# TOWN PLANNING REPORT

Application under Section 4.55(1A) of the Environmental Planning and Assessment Act 1979 to modify Development Consent No. 10.2019.331.1

Reconfiguration of the approved dwelling including relocation of one of the bedrooms to the lower floor, adding a bathroom to the relocated bedroom and repositioning the kitchen and laundry areas

Lot 17 DP 1252223  
No. 9 Clover Hill Circuit, Bangalow

**FLOOR PLAN**

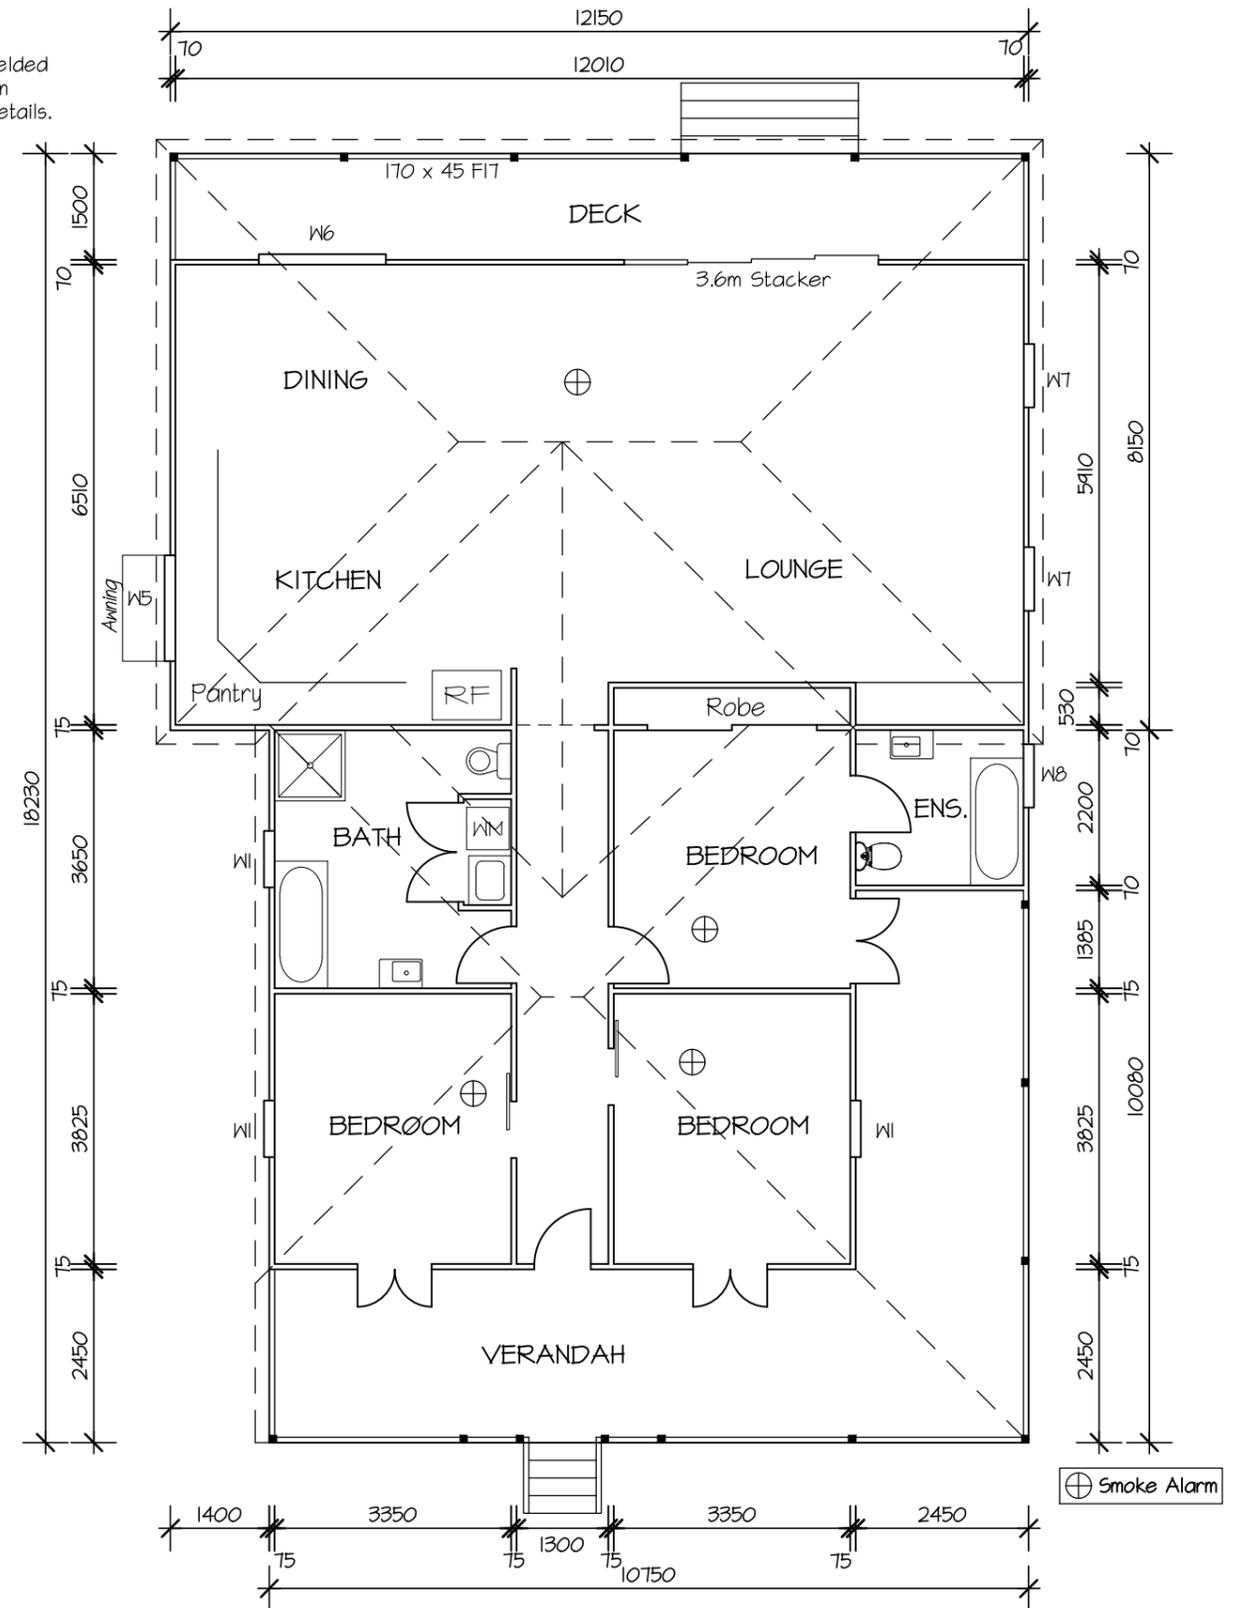
1. Relocation of a bedroom from the upper floor to the lower floor.
2. Addition of an ensuite to the lower floor bedroom.
3. Repositioning of the laundry space within the lower floor to the western side of the building adjoining the bedroom and ensuite.
4. Repositioning of the kitchen space within the upper floor to the southern side of the open plan living area.
